ORIGINAL PLAN SETS- APPROVED- AR -29389

LANDSCAPE CHANGES-

MODIFICATIONS TO ORIGINAL APPROVED LANDSCAPE DRAWINGS - AR -29389
AND CHANGES SHOWN AS PER AR- 28214

DRA 2 PARKING - EVENT CENTER
REV-LANDSCAPE-IRR PLAN
SOUTH PROJECT

SHT LD-COVER-REV

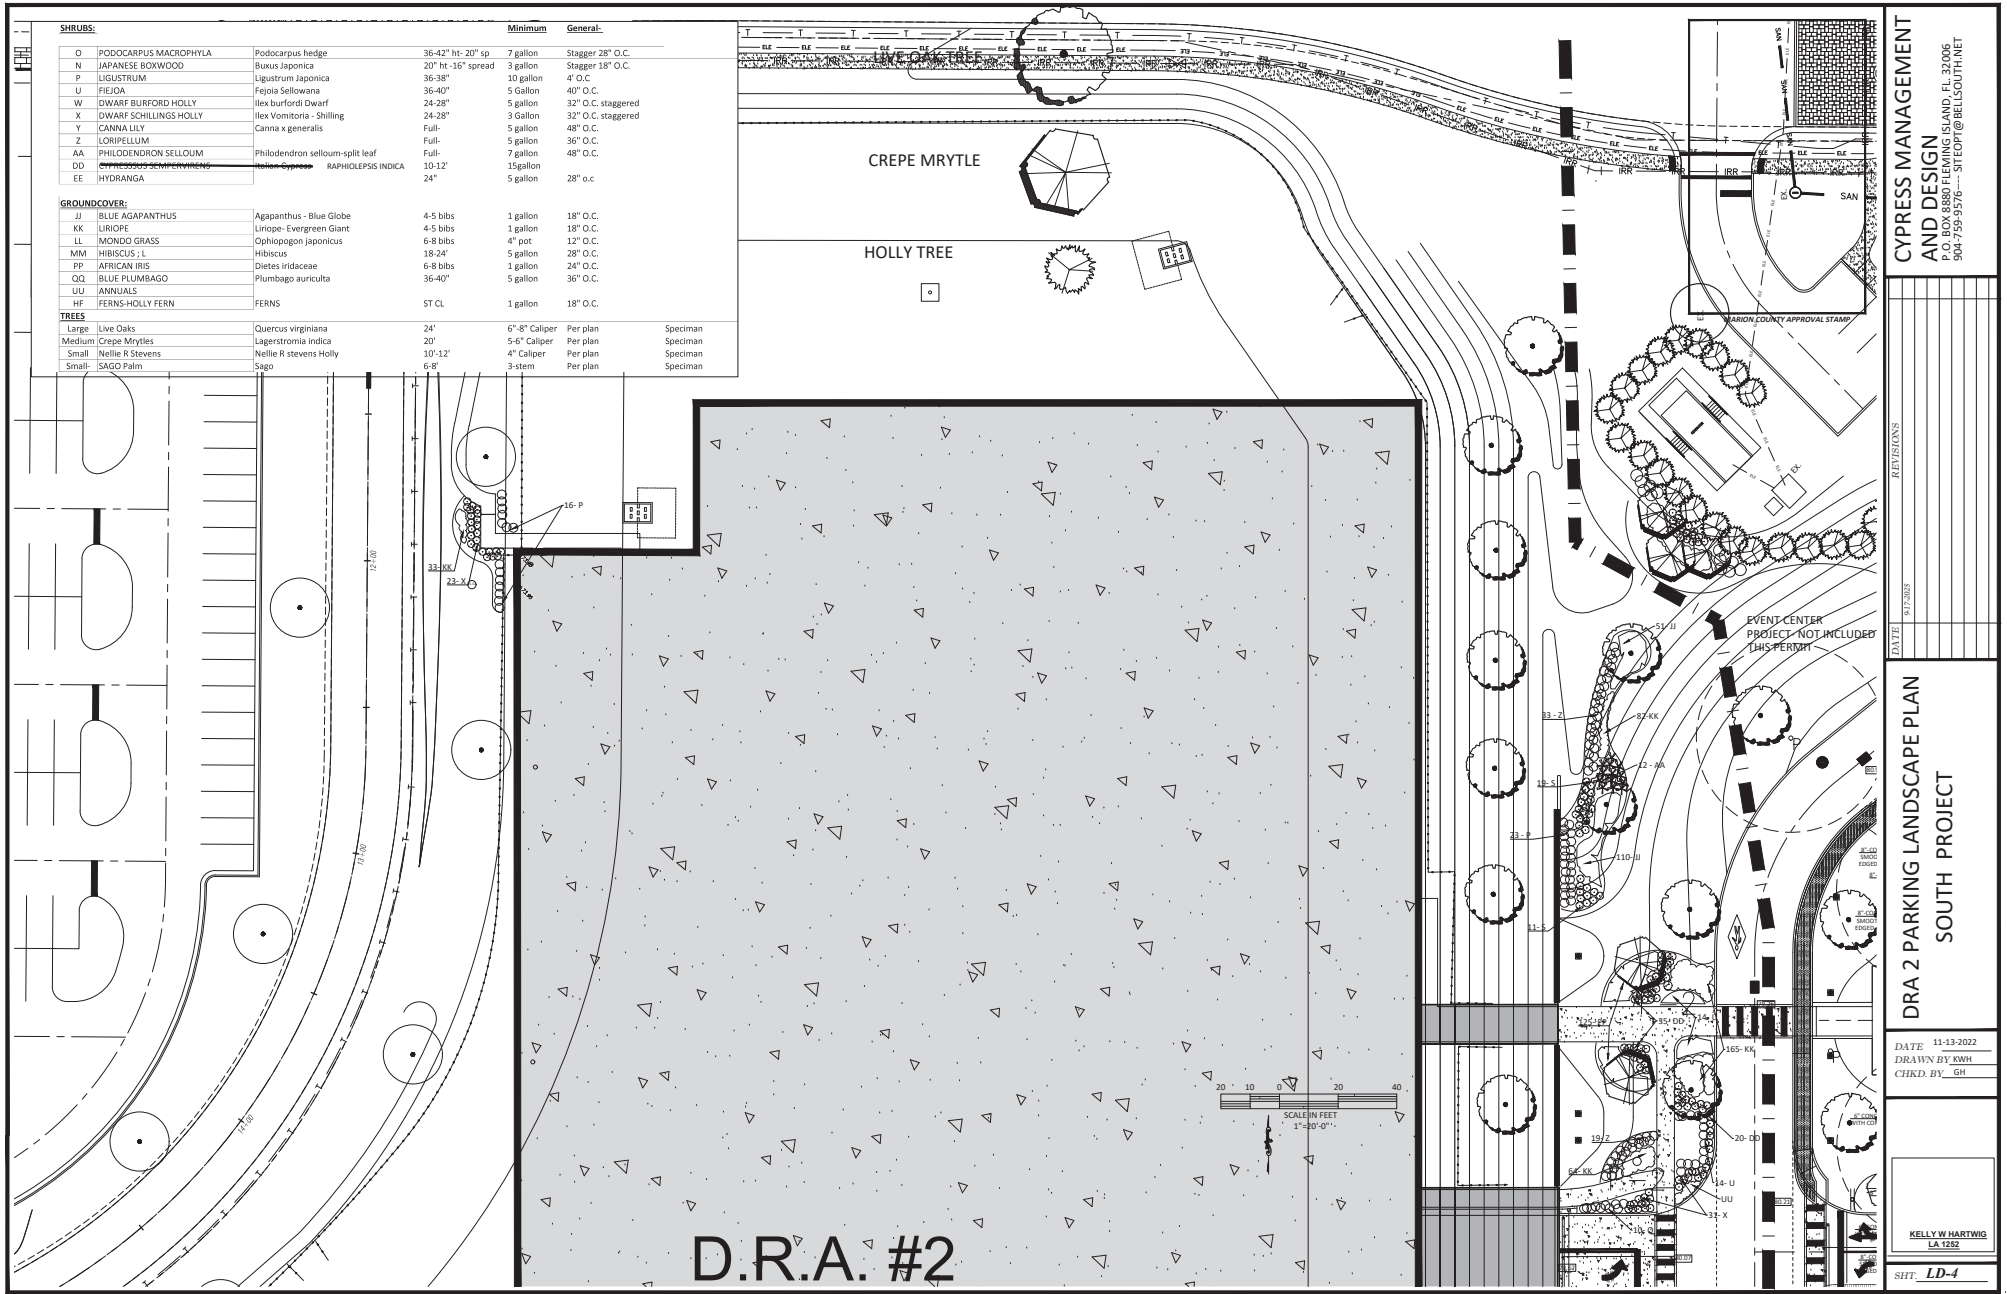
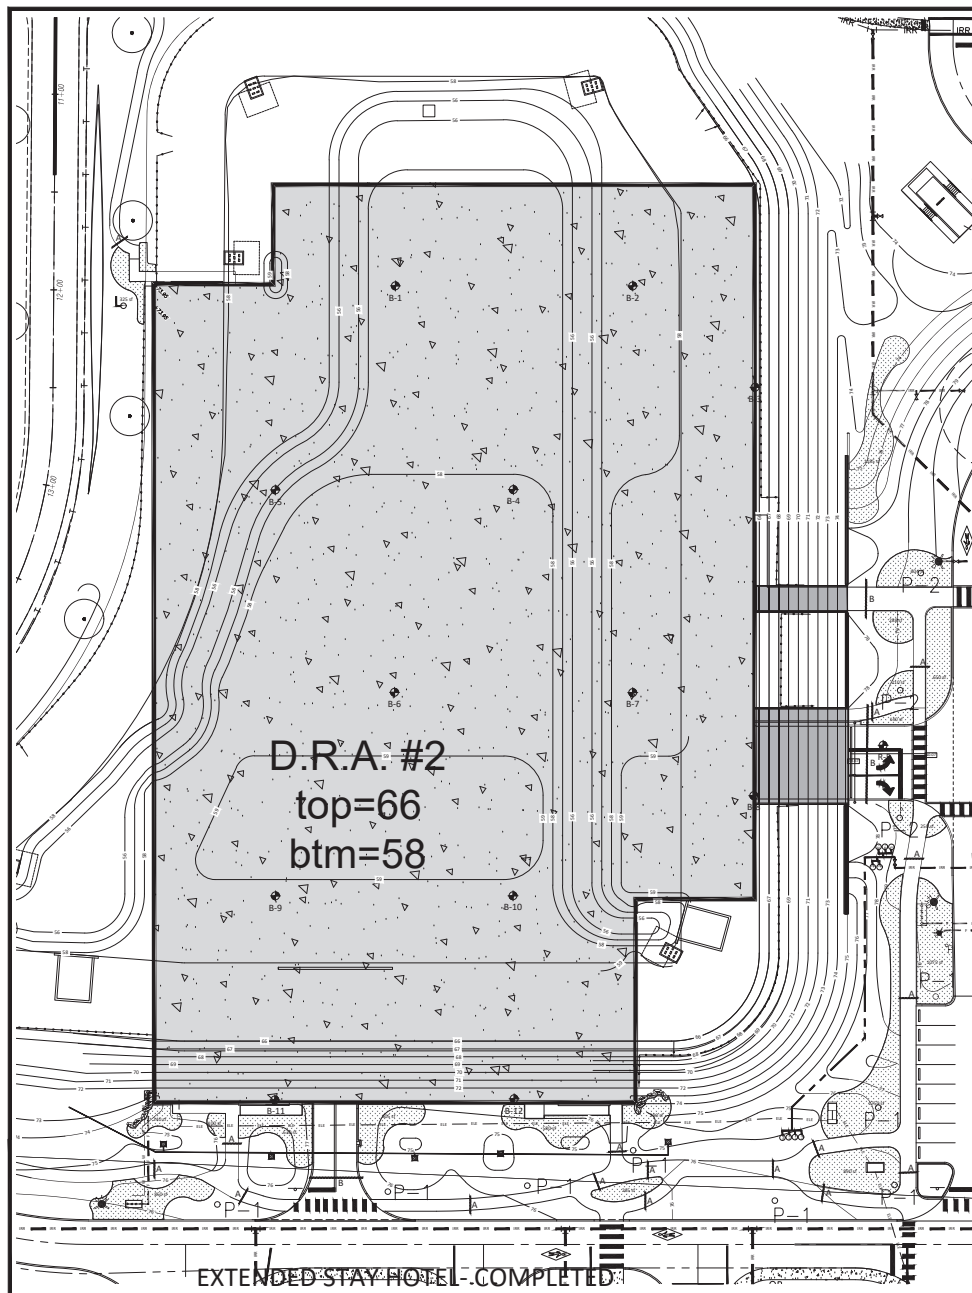
DRA 2- PARKING DECK-BUILDING PERMIT NUMBER: 2024060796
L-3- Replaces L-7
L-4- Replaces L-7
L-5- Added specifications
L-6- Replaces IRD-8
L-7- Replaces IRD-8
L-8- Replaces L-5 and L-6
L-9- Replaces L-5 and L-6
L-10- Replaces IRD-11

EVENT CENTER - BUILDING PERMIT NUMBER 2022111718
L-10- Replaces L-5 and L-6
L-11- Replaces IRD-11

CHANGES TO LANDSCAPE CALCULATIONS:

MINIMUM LANDSCAPE REQUIREMENTS:
PROJECT AREA- 28.31 acres
See below
TOTAL GREEN AREA--- 57% GREEN AREA No Change
BUFFERS- PER PUD-1133 total road frontage- No Change
Only 400' requires buffer per PUD No Change
Provided 1133' FRONT 20' wide 50% planting No Change
WILL HAVE AVERAGE 76" PLANTING No Change
Calculations shown on each sheet
NO SIDE OR REAR BUFFER REQUIRED
PERIMETER PARKING LOT LANDSCAPE REQUIRED- Provided
BUILDING PUBLIC SIDE- 510LF - Waiver requested- No Change- approved
INTERIOR ISLANDS- REQUIRED BY CODE-Provided
ALL SERVICE AREAS AND ELEMENTS ARE SCREENED- No Change

TOTAL PLANTED AREA- 18,000 SF- SHRUB AND PLANTED AREA Added 1400 sf
BALANCE OF GREEN AREA- SOLID SOD-BAHIA SOD IN NON-IRRIGATED AREAS No Change
BERMUDA OR ST AUGUSTINE IN ISOLATED IRRIGATION AREAS NEAR BUILDING No Change

NEW TREES:
Live Oak Trees- Added 7 additional trees these two projects
Ornamental trees- Deducted - 1 Crepe Myrtle

SHT. LD-11

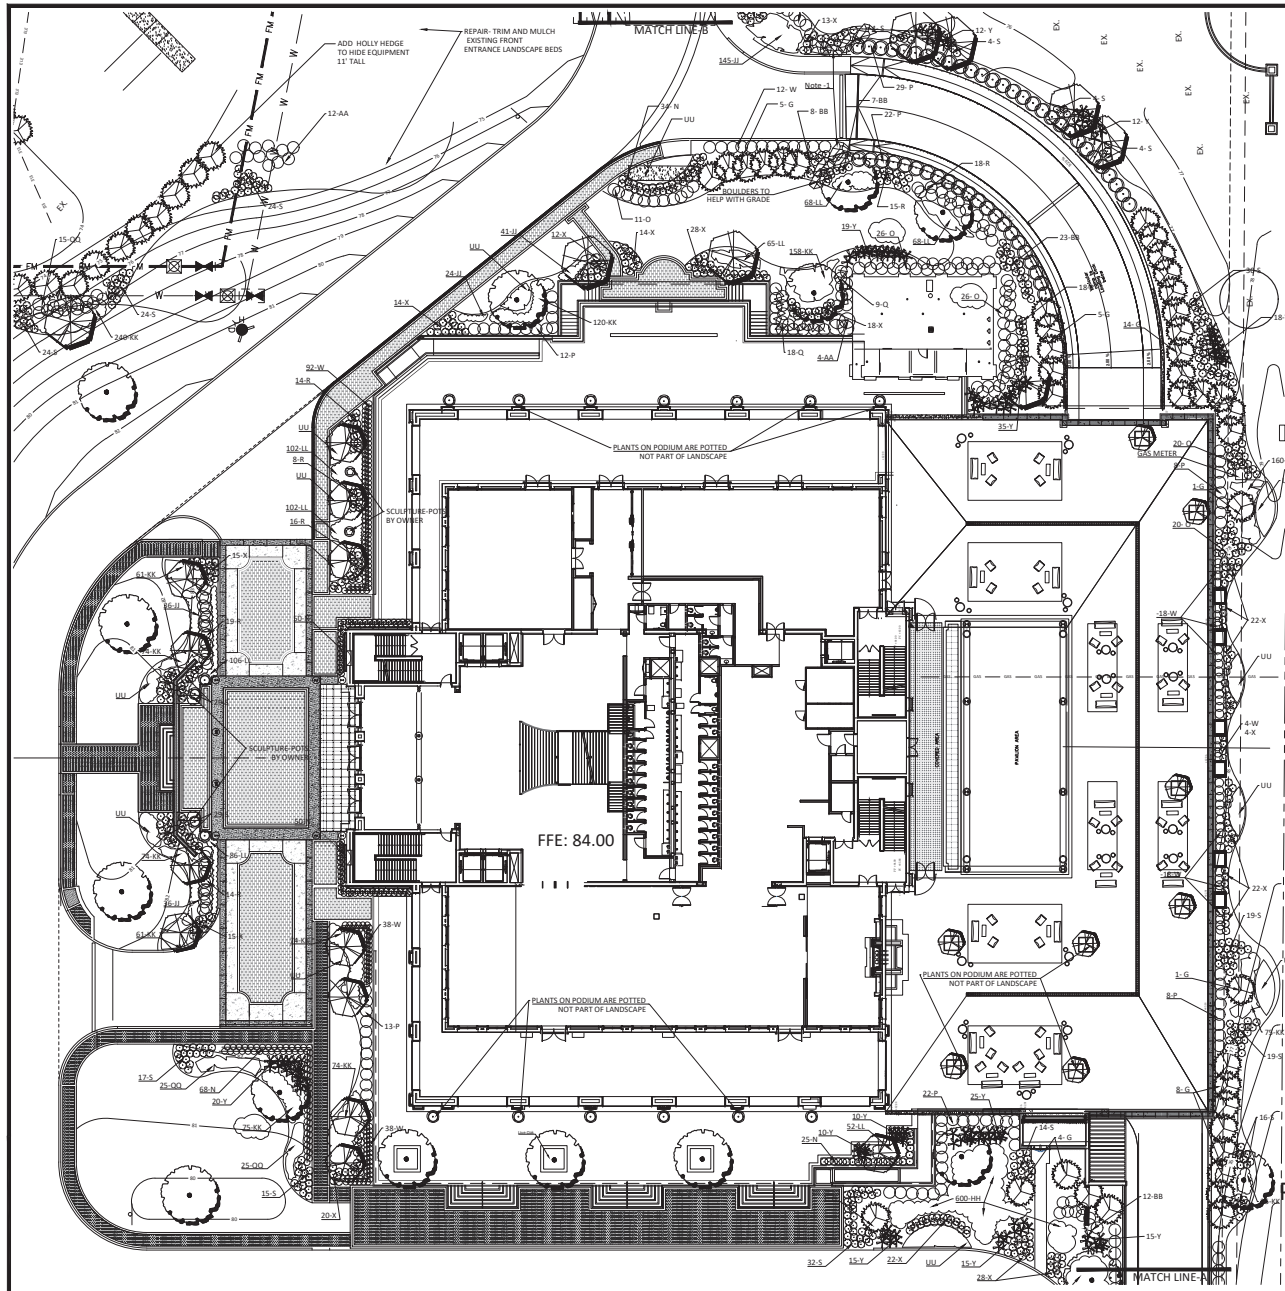
FINAL EVENT CENTER IRRIGATION

SHT. LD-10

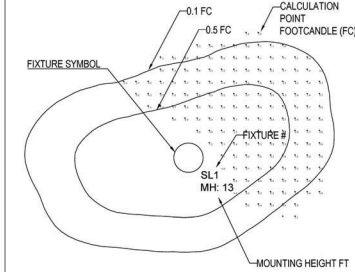
NOTE 1- SMALL ROCK LEDGE- 2 ROCK HIGH FILTER FABRIC - OWNER WILL PROVIDE BOULDERS- LANDSCAPER WILL INSTALL PLAN ON 18 BOULDERS (10- SOUTH, 8 NORTH)

NOTE 2- GRASS WILL BE ST AUGUSTINE -SOLID SOD

FINAL CHANGES- PLANTING-EVENT CENTER
